TECHNICAL REPLY

**To The Response by the Ramble Community
Development Committee to the Draft Environmental
Impact Assessment of the Proposed Cemetery at
Burnt Ground, Hanover.
May 27th 2007**

Environmental Management Consultants (Caribbean) Ltd.
61 Mansfield Meadows, Ocho Rios, St. Ann, Jamaica
rburrowes@eiacaribbean.com
876-974-9727

Figure 1 Burial Space at Burnt Ground Cemetery Site

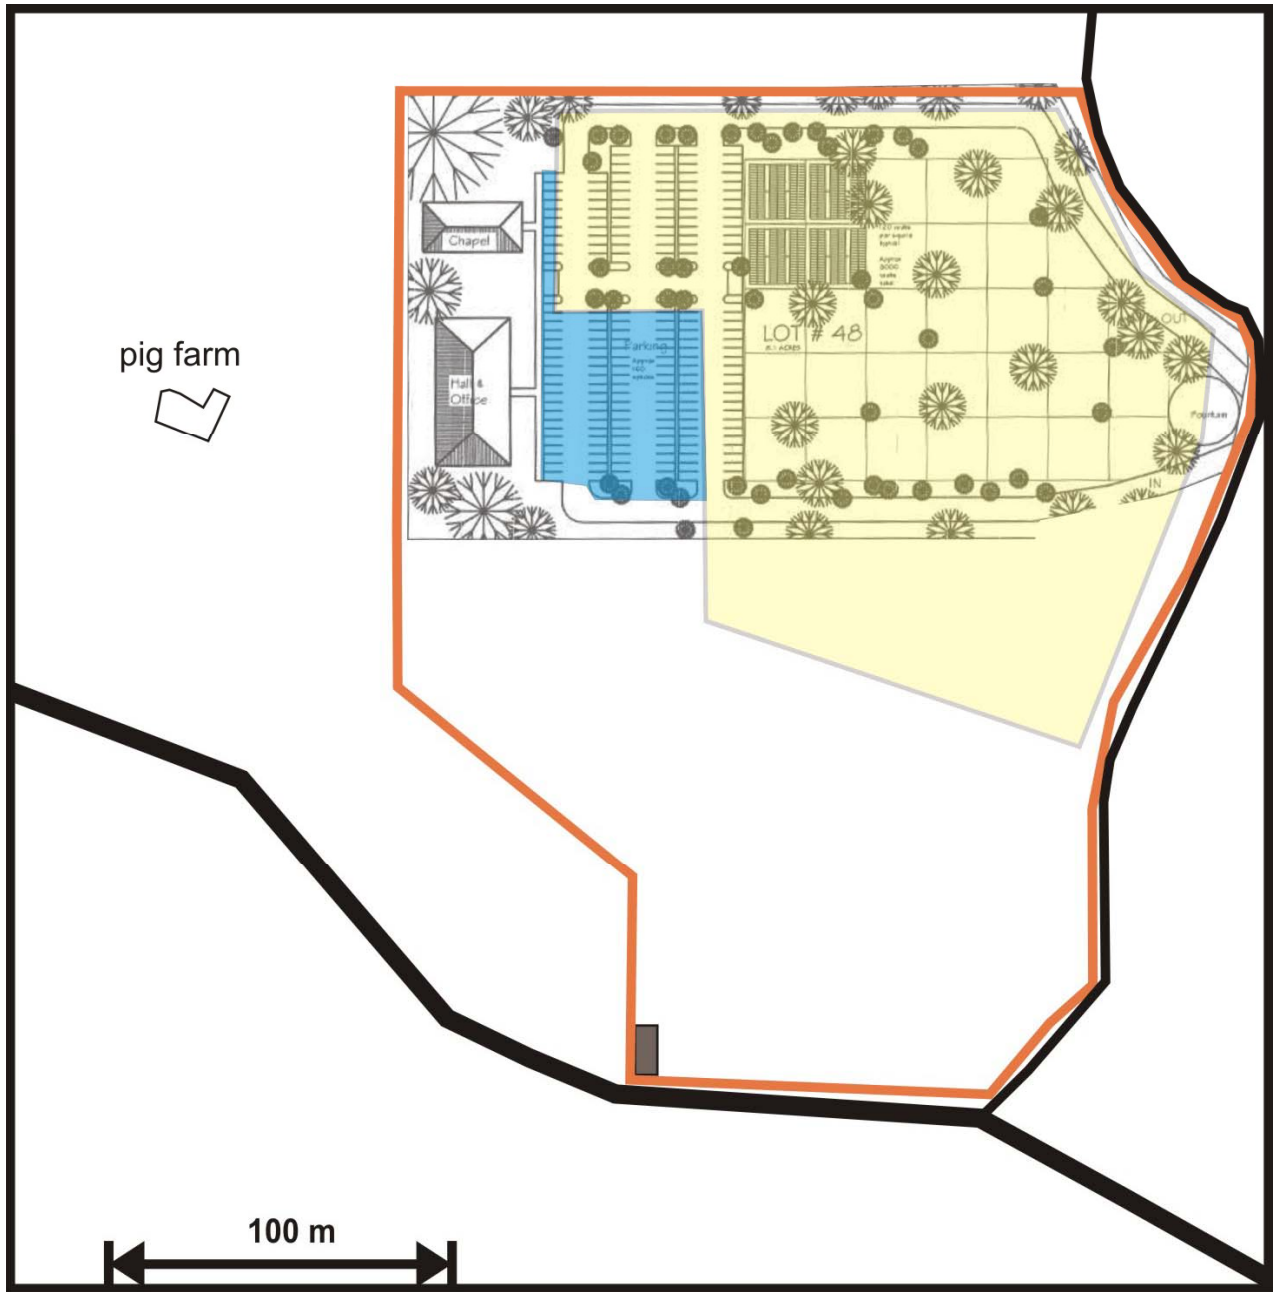
In practical terms Lots 47 and 48 should be regarded as one development lot. There is enough space in Lot 48 available to accommodate the cemetery's needs if it was desired not to allow any development on Lot 47. Later in the response there is a question of whether the area to the east of

the pond is suitable for burials. All areas immediately around the front pond have been excluded (see Figure 1).

Figure 2 Schematic Profile

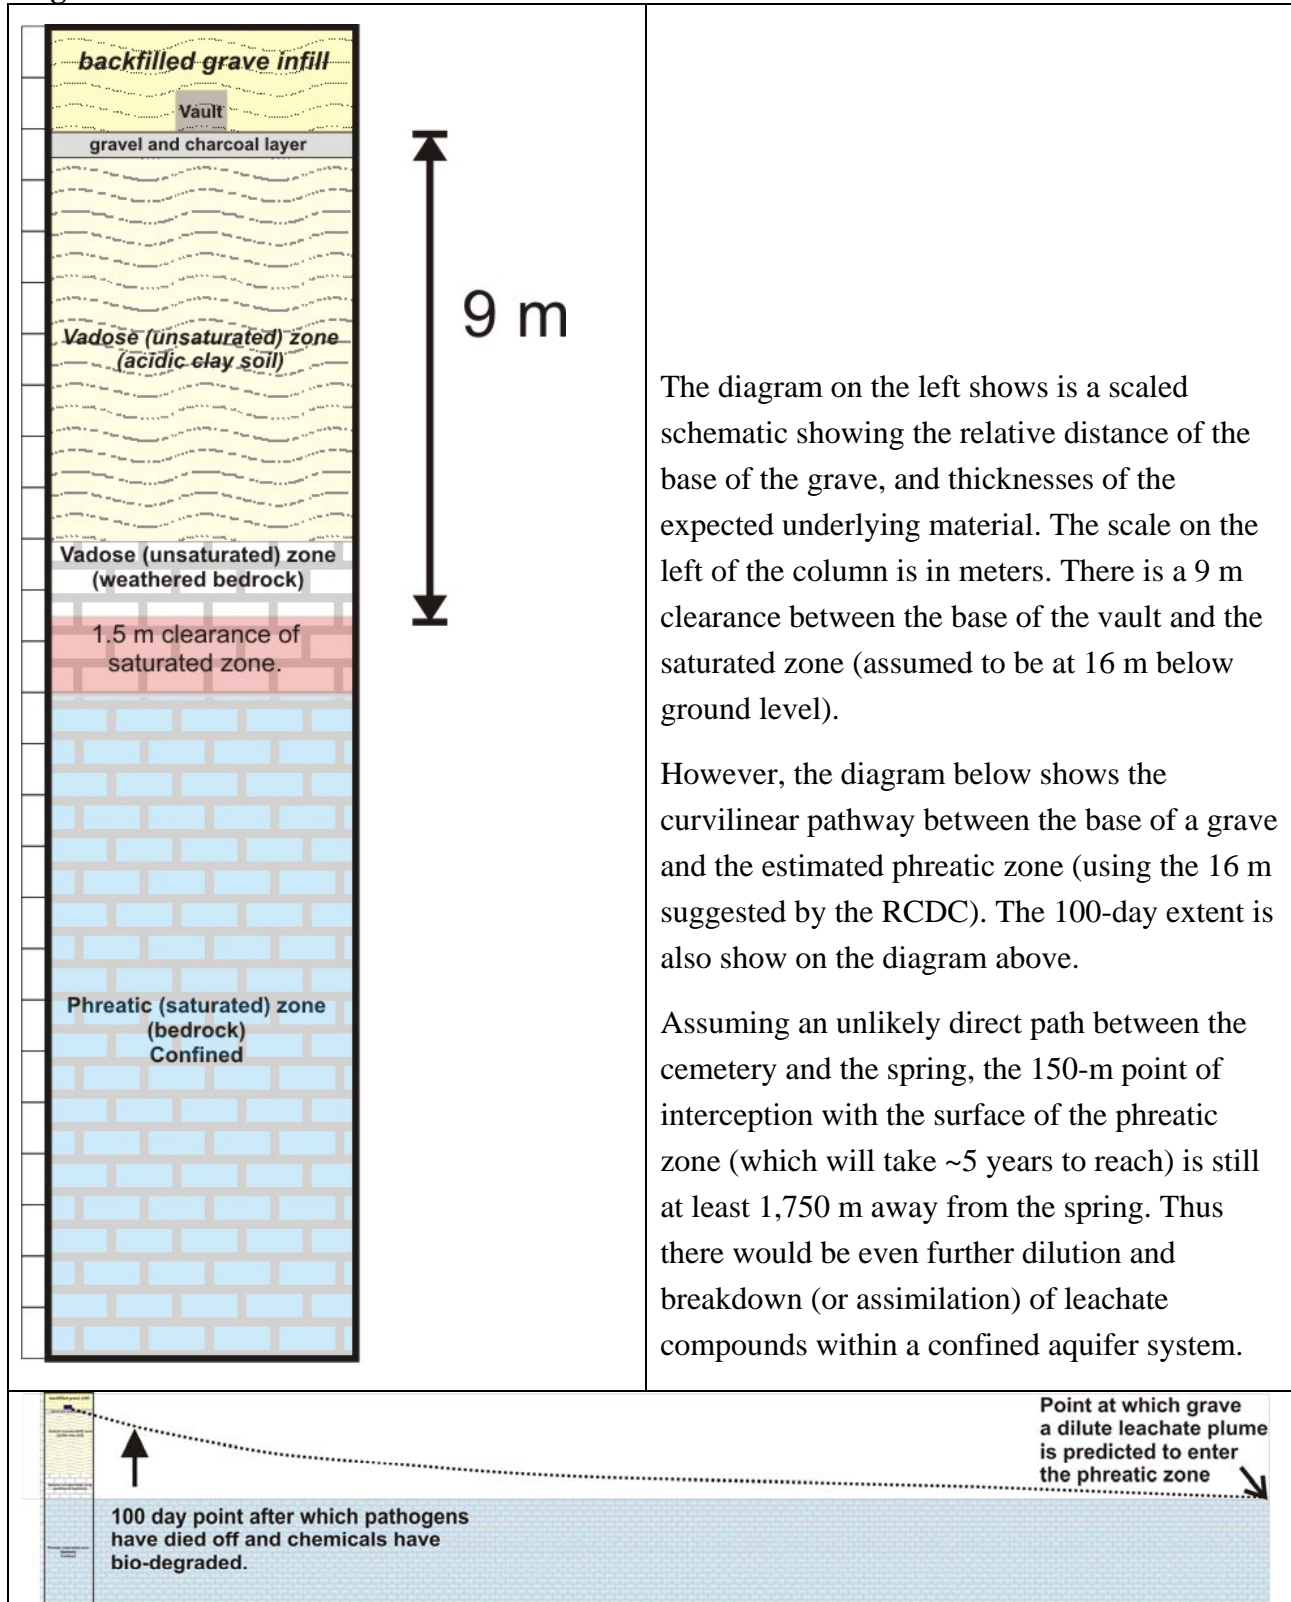
Bullet 7 (p6): *“Calculations concerning the lateral movement of the pollutant are presented in the report, but none for the vertical movement downwards which would take the pollutant in the groundwater”*. The 8 m 100-day travel time is along the hydraulic gradient. In the case of the unsaturated zone there is no hydraulic gradient, so the pathway can be taken as a combination vector (horizontal and vertical, or better horizontal flow pulled downward by gravity) with a significant horizontal component in view of the fine soils and other site factors. The modeled percolation rate of 8.1m per 100 days represents a **worst case** scenario, and suggests that it will be less than this.

Based on the available data from the boreholes, the soils on the site are 10 m thickness on average, thus after an interment 2.5 m depth, there will be ~7.5 m of soil above the bedrock (Figure 2). If an interflow on a 5% gradient (2.86°) was applied to this, water would reach the soil-bedrock interface in about 150 m laterally, taking more than 5 years (based on the evaluated hydraulic conductivity). The model was developed for a presumed worst case scenario. In reality groundwater movement in the soil is likely to be more retarded than the model used.

The Community's borehole opposite the site indicated that groundwater was present in the bedrock at 16.2 m below ground level. The ground at this site is below the average topography of the proposed cemetery and it seems likely that the regional groundwater, if and where present, would be even lower than the 16 m. Even conservatively, this suggests that the vertical distance between the grave base and any possible groundwater table would be more than 13 m (Figure 2).

The rate of transmissivity in the phreatic zone (in bedrock) is simply not relevant because leachate from the base of the grave would take such a long time to reach the phreatic zone that it would be innocuous by the time it got there (see Figure 2). Deep, clayey and acid soils are ideal for retarding, and permitting reaction with, any deleterious solutes (organic, salt or metal), and permitting the decay and burn-out and de-naturing of bacterial populations or viruses.

Figure 3 Schematic Cross Section between the Cemetery Site and the Spring

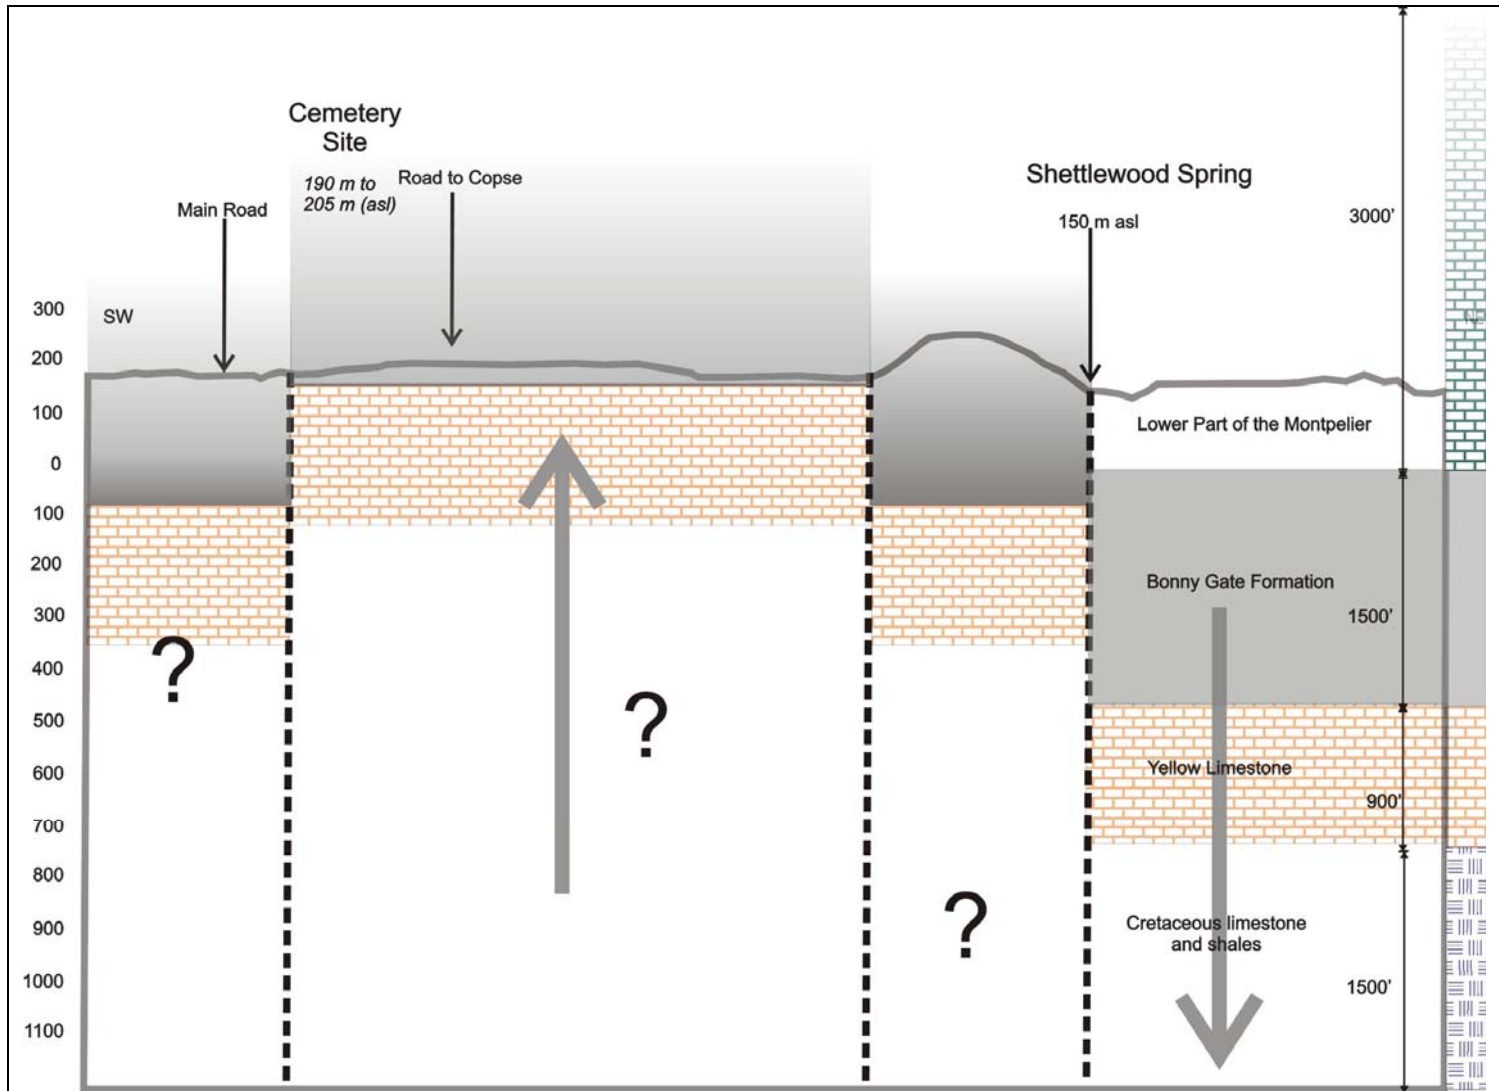
“The cemetery is immediately above the gravitational system which is the Shettlewood Spring, and is therefore linked to it by virtue of the certainty that the aquifer exist at a depth of fifty (50) feet below the surface and will be polluted by chemicals and other water borne diseases arising from the decomposition of human remains, if this development is allowed to take place.”

Figure 3 is a schematic cross section between the cemetery site and the spring, showing a possible hypothetical scenario for the underlying geological succession. The bedding is shown as horizontal because available structural information (published geological map) shows the strike of the beds to be parallel to the section between the site and the spring. If the northeast strike is correct, the beds are dipping gently (12 degrees) to the northwest (back into the page). Figure 4 shows line of section use. Although the cemetery site is located a higher elevation than the spring, the following must be considered in evaluating the validity of a straight line connection between the two:

It must be cautioned that this visual interpretation is only intended to represent a possible scenario, and is not being submitted as the actual geology of the area. It is included at this time as a means of representing an alternative scenario to the “gravitational system” being posited by the Ramble CDC.
